UPPER UWCHLAN TOWNSHIP
BOARD OF SUPERVISORS WORKSHOP

August 13, 2024
4:00 p.m.

- I. Call to Order
 - A. Salute to the Flag
 - B. Moment of Silence
 - C. Inquire if any Attendee plans to audio or video record the Workshop
 - D. An Executive Session was held July 15, 2024 regarding a legal matter for a Conditional Use Decision and regarding personnel – Boards/Commissions candidates.
- II. Park & Recreation Board ~ Junior Member Appointment
- III. Village Concept Plan ~ Updated

DATE:	DECEMBER 4, 2023	SHEET:
SCALE:	AS SHOWN	15
SURVEY:	---	
DRAWN:	MDC	
CHECKED:	VK	
DRAWING NO.	202317-1(C)	OF: 16

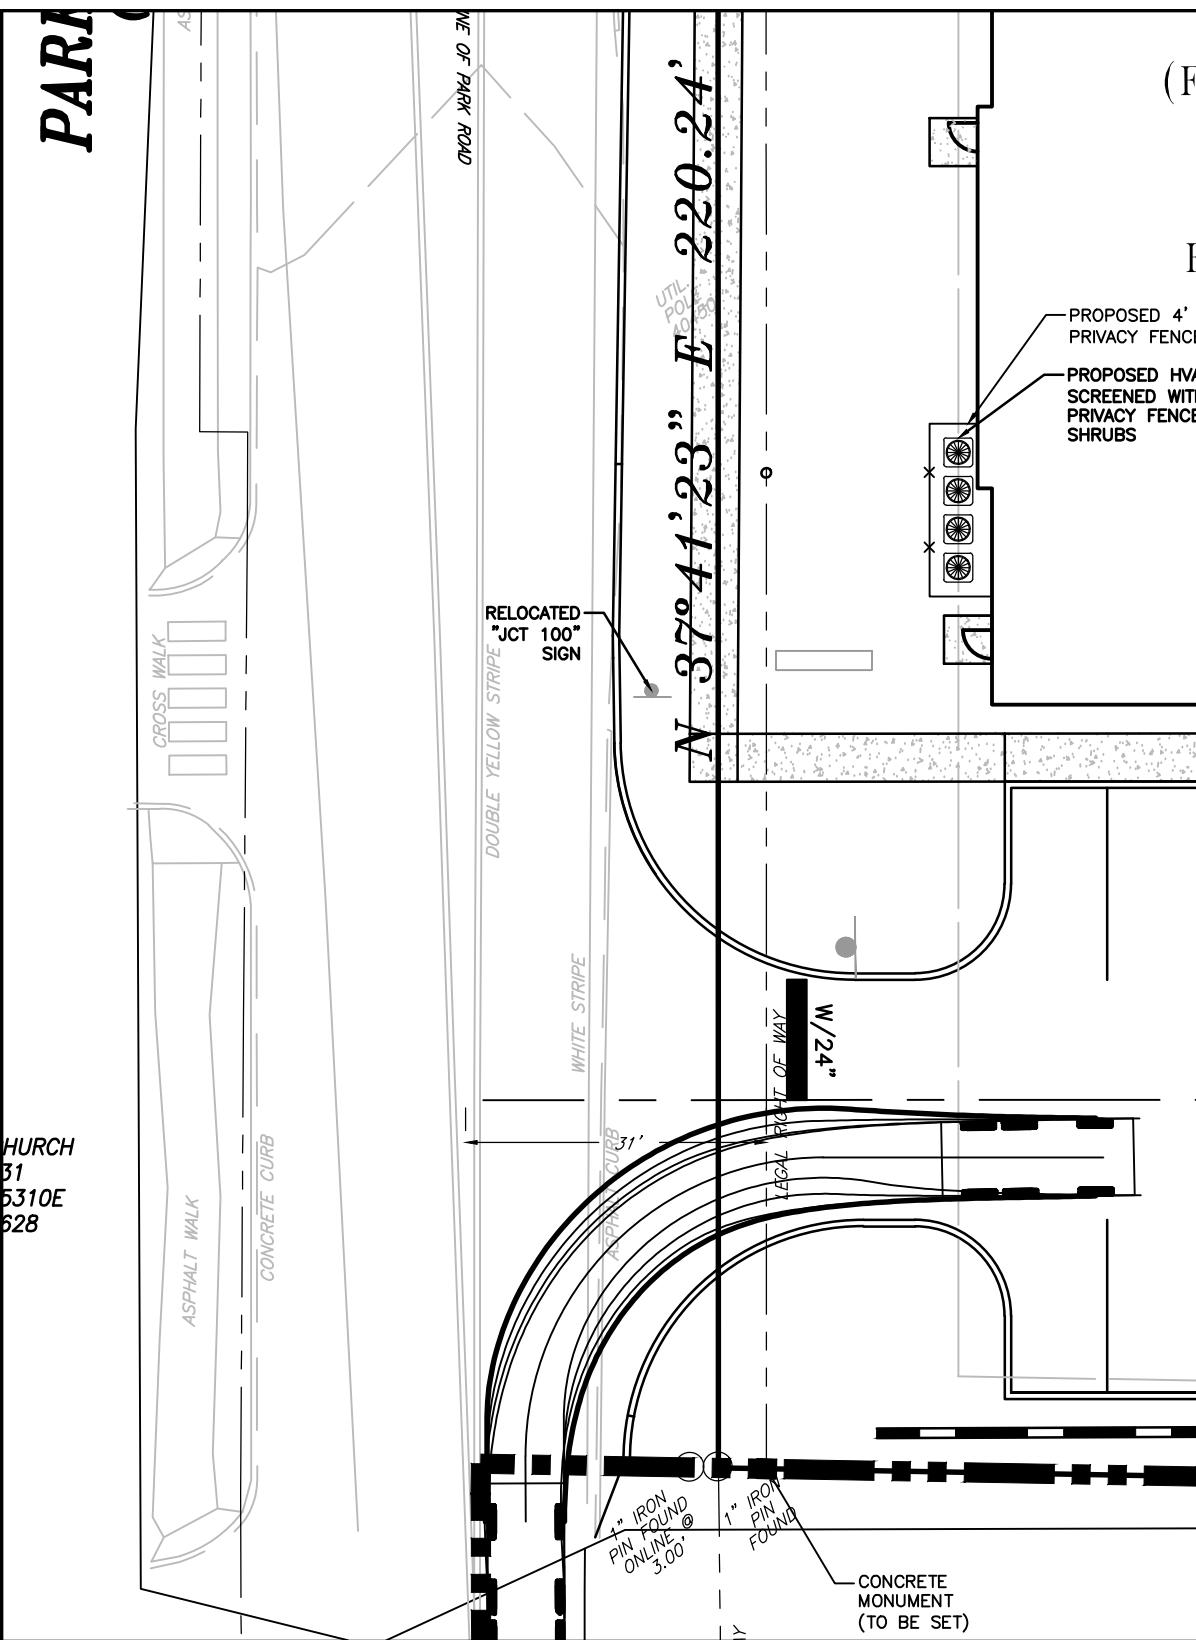
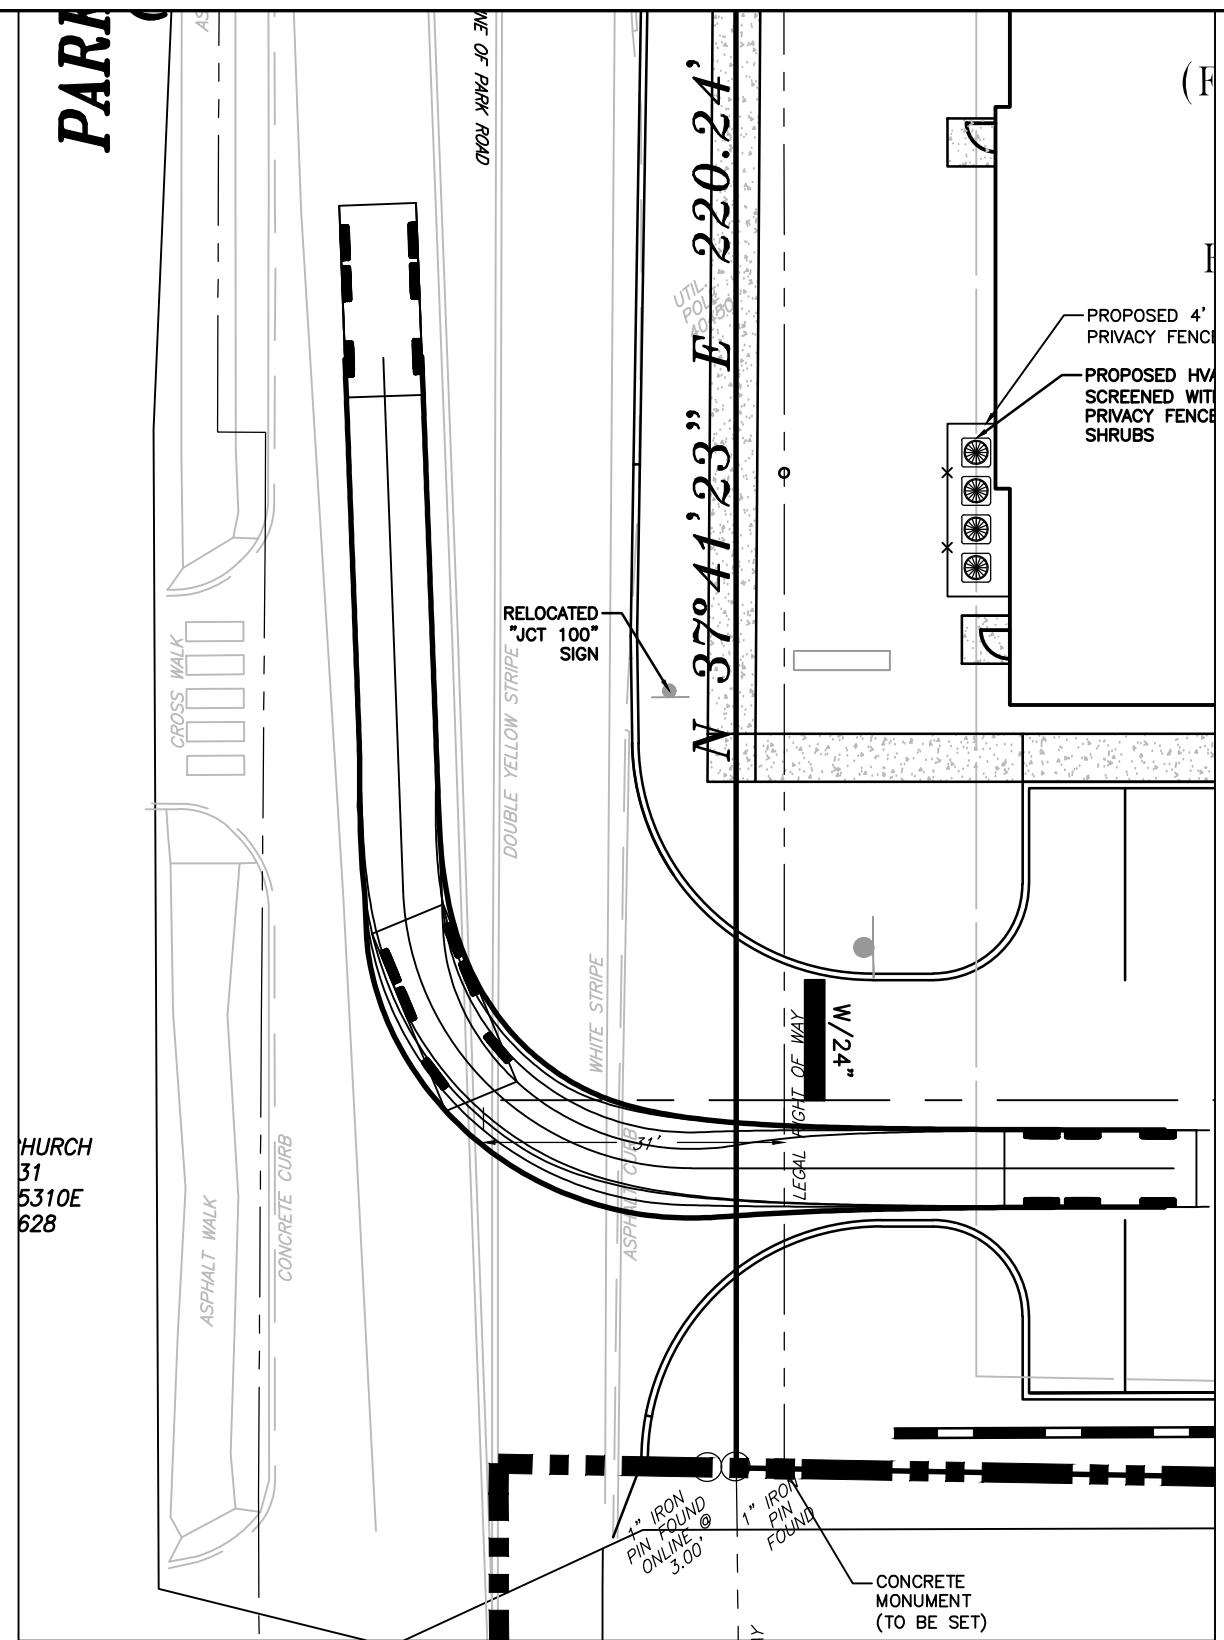
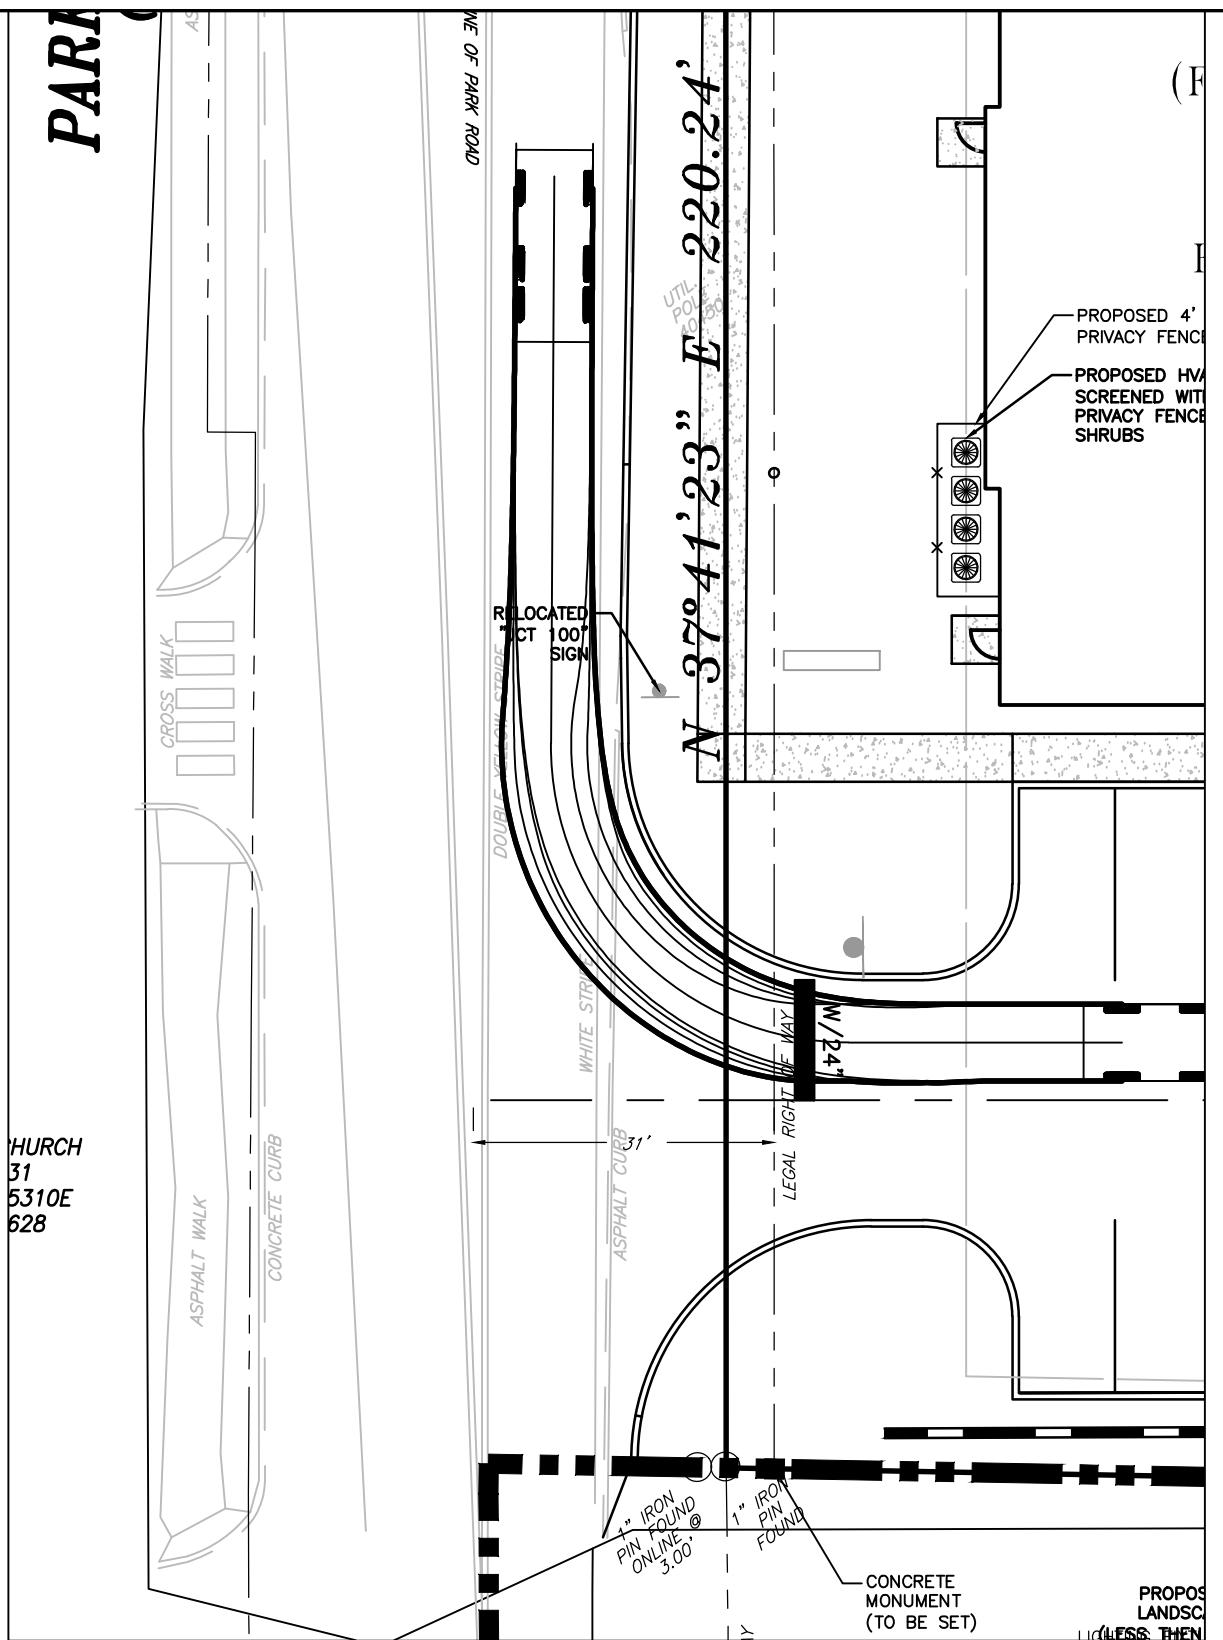
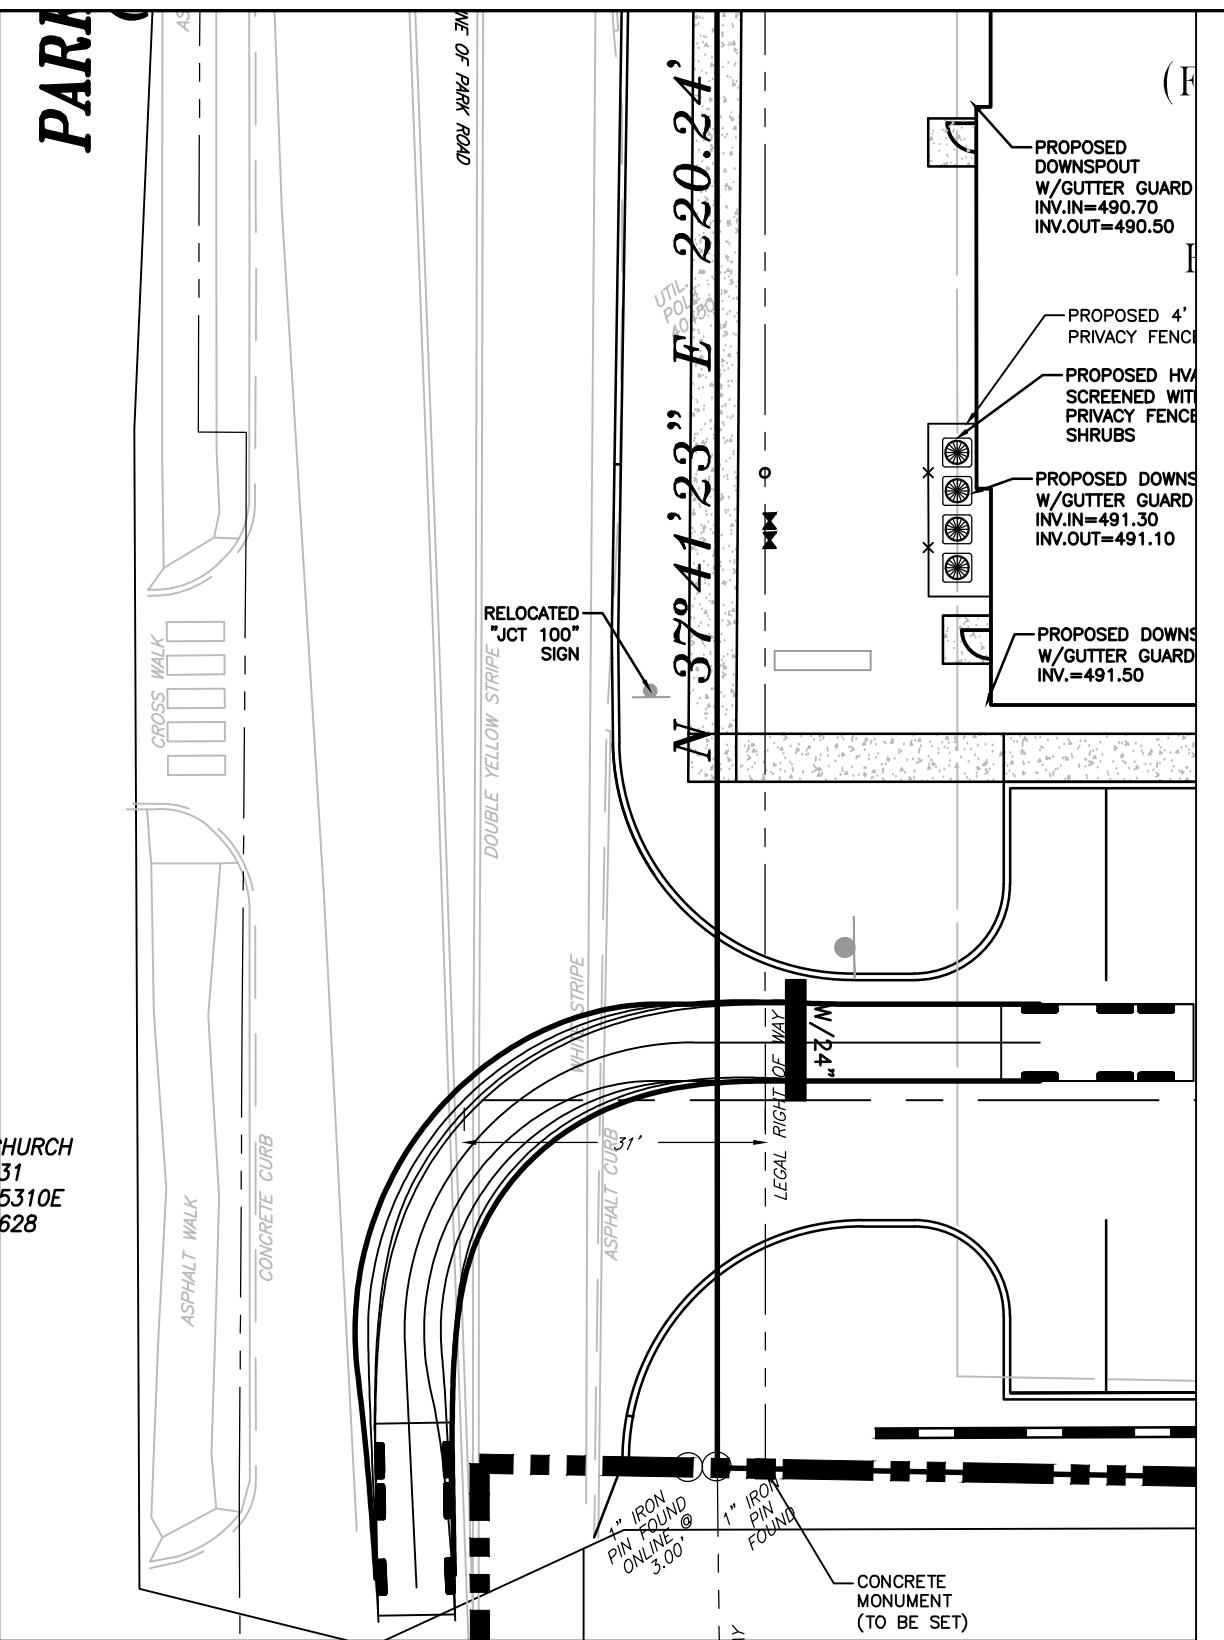
- 5. The sight line for left-turn entering vehicles looking ahead has been revised and is now measured from a point in the south bound lane, 35-feet east of the centerline of the proposed driveway to a point in the center of the north bound lane, 324 feet west of the centerline of the proposed driveway. (See Sheet 15 of 16)
